Staff Report

Site Plan Review

SP-03-24

Proposal:	To construct a new 2,160-square-foot accessory structure.
Review Body:	Staff (Type I-L review)
Applicant/Property Owner:	Christian Cashen, 2333 Waverly Drive SE, Albany, OR 97322
Address/Location:	2333 Waverly Drive SE, Albany, OR 97322
Map/Tax Lot:	Linn County Tax Assessor's Map No. 11S-03W-17A Tax Lot 208
Zoning:	Residential Single Dwelling Unit (RS-6.5)
Overlay Districts:	Airport Approach District
Total Land Area:	0.93 acres
Existing Land Use:	Residential
Neighborhood:	Periwinkle
Surrounding Zoning:	North: Residential Single Dwelling Unit (RS-6.5) East: Residential Single Dwelling Unit (RS-5) South: RS-6.5 West: RS-6.5
Surrounding Uses:	North: Single-dwelling unit residential East: Single-dwelling unit residential South: Single-dwelling unit residential West: Single-dwelling unit residential

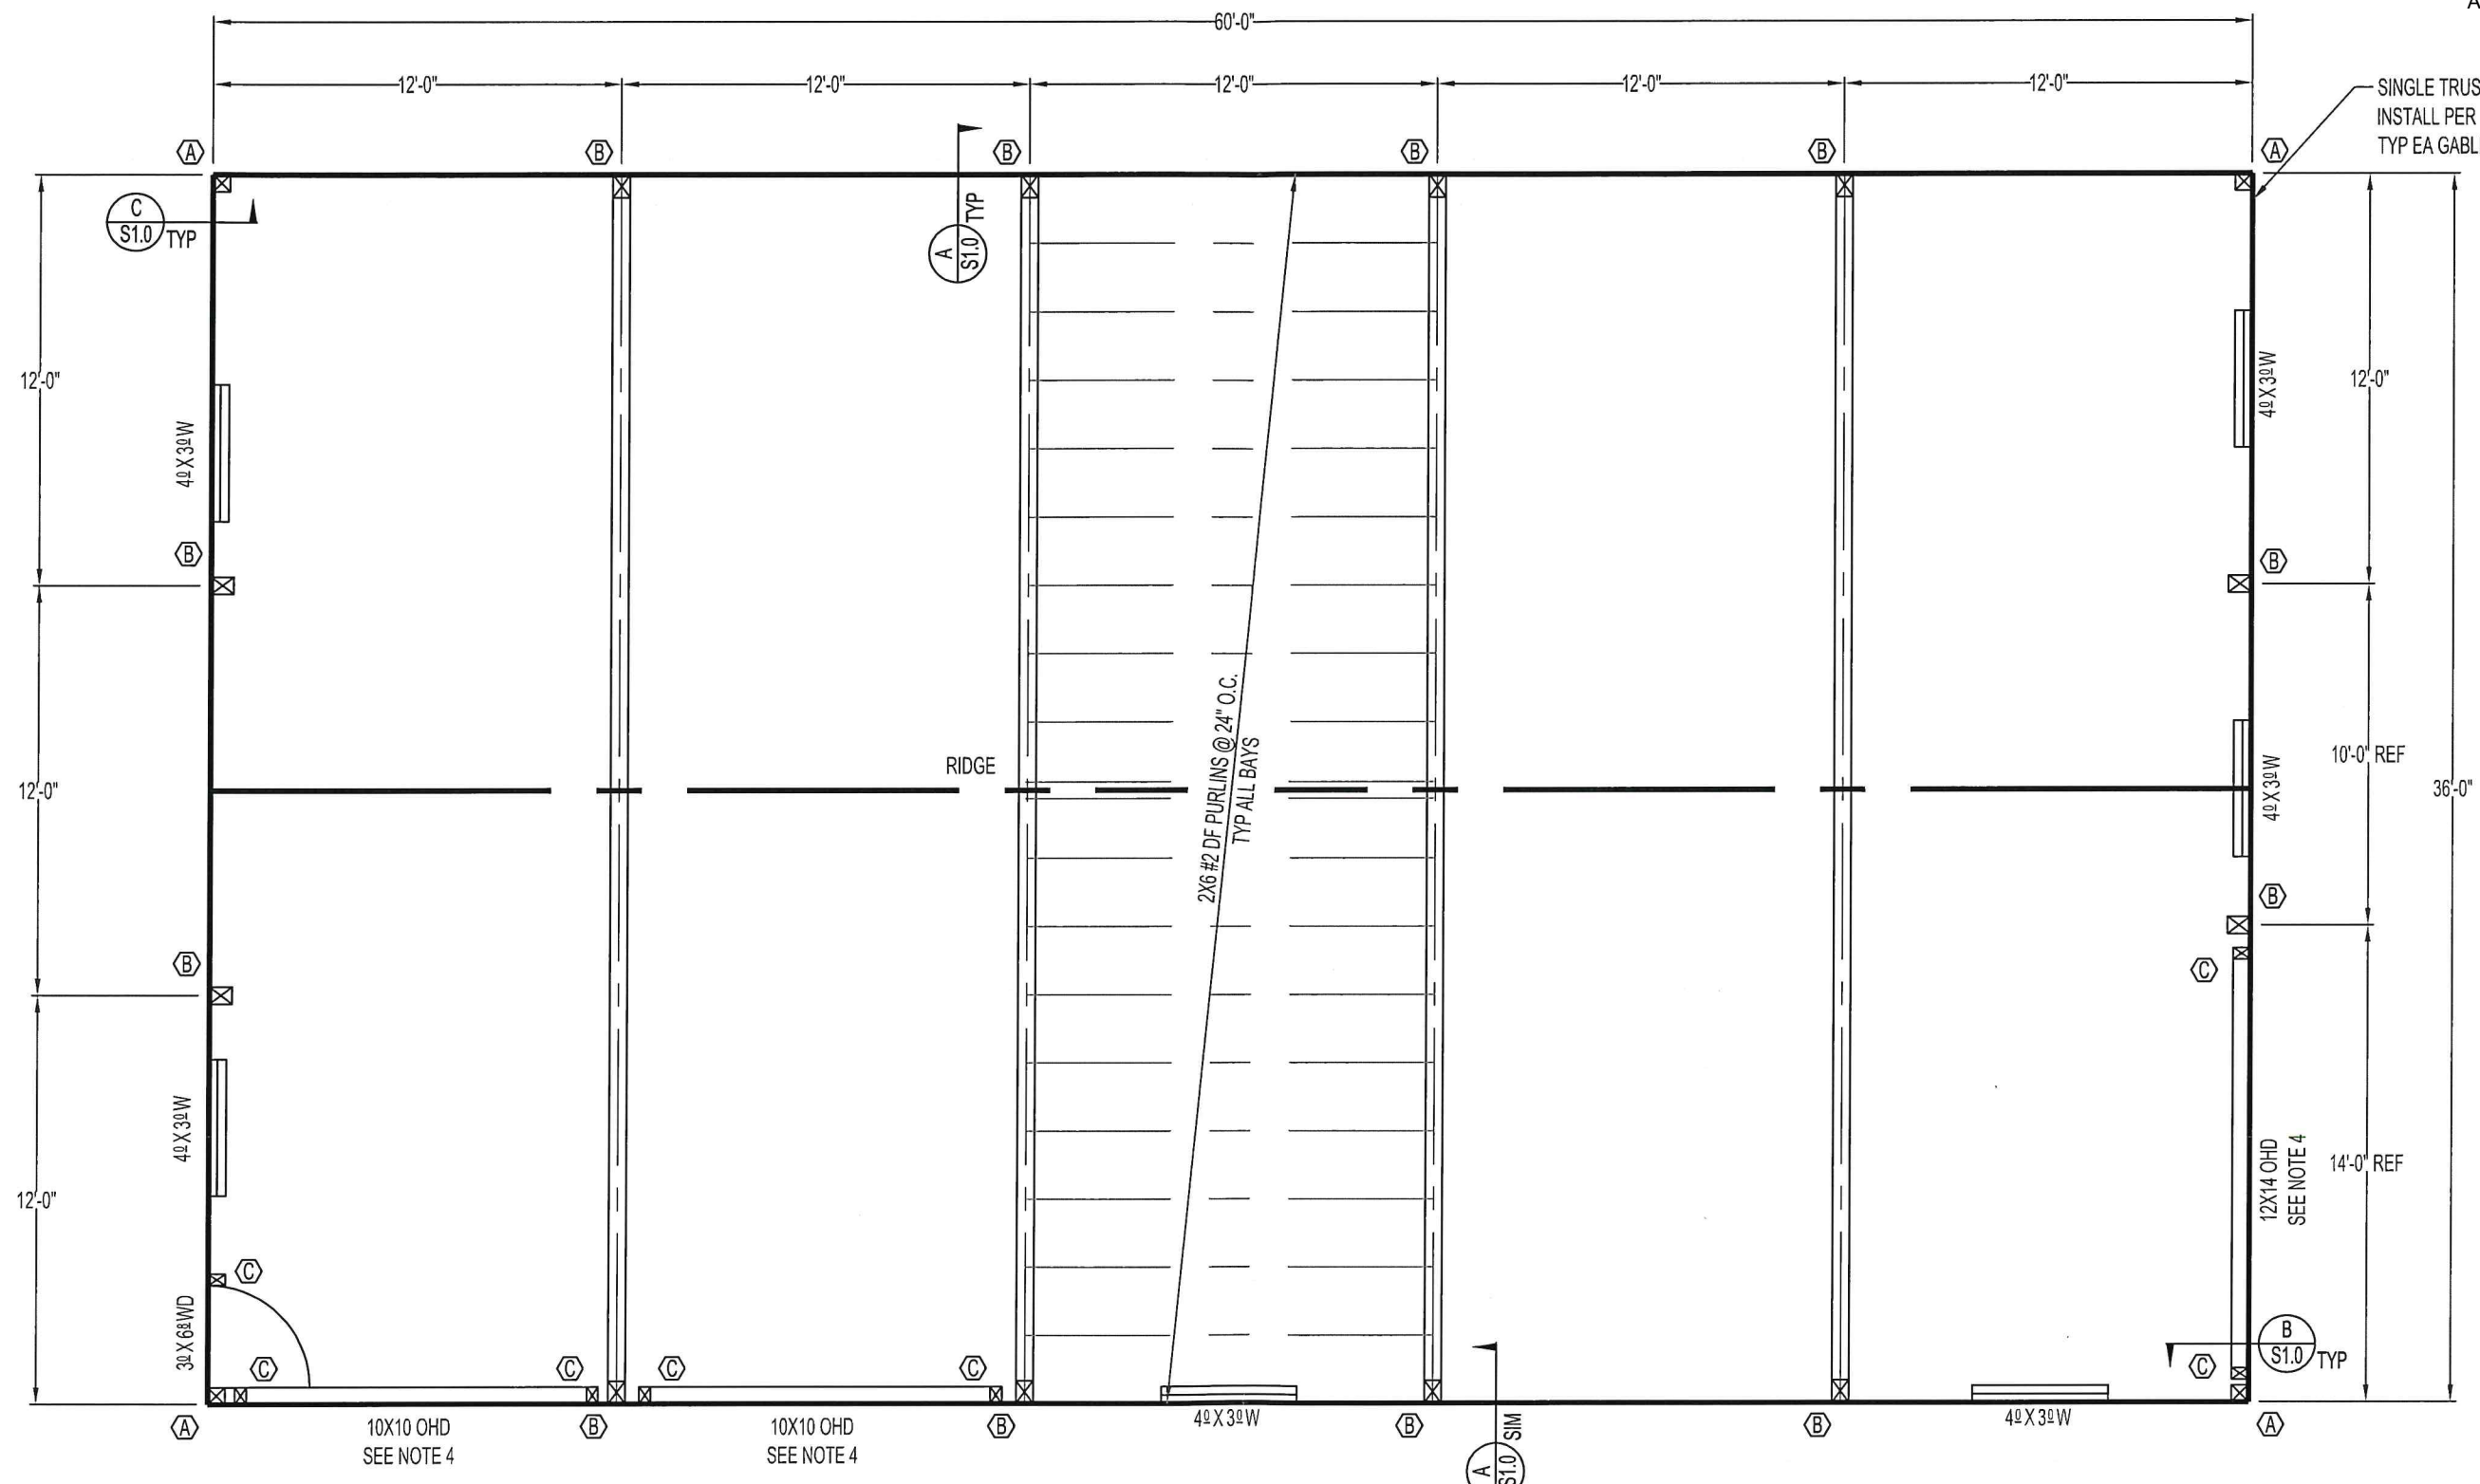
- 2.1 Per ADC Table 3.190-1, the minimum front setback is 15 feet. The minimum interior setback for detached structures with walls greater than eight feet tall is five feet. The proposed accessory structure is to be used as a personal shop. The building plans indicate bay doors on the structure (Attachment C). The minimum setback for garages with a vehicle entrance is 20 feet. While the applicant has not indicated that the structure is a “garage” the building is being constructed with a vehicle entrance. The site plan (Attachment B) submitted by the applicant indicates the proposed accessory building will meet the minimum front setback of 15 feet from Waverly Drive SE, the 20-foot setback for vehicle entrances, and the interior setback of five feet.

- 2.2 The lot dimensions do not change with the proposed accessory structure.
- 2.3 Per ADC Table 3.190-1, the total lot coverage allowed in the RS-6.5 zone is 60 percent. With the proposed accessory structure, the total lot coverage will be 13.98 percent.

- 2.4 Per ADC Table 3.190-1, the maximum height allowed in the RS-6.5 zone is 30 feet. The total height of the proposed structure is approximately 22.5 feet, with a wall height of 16.5 feet.
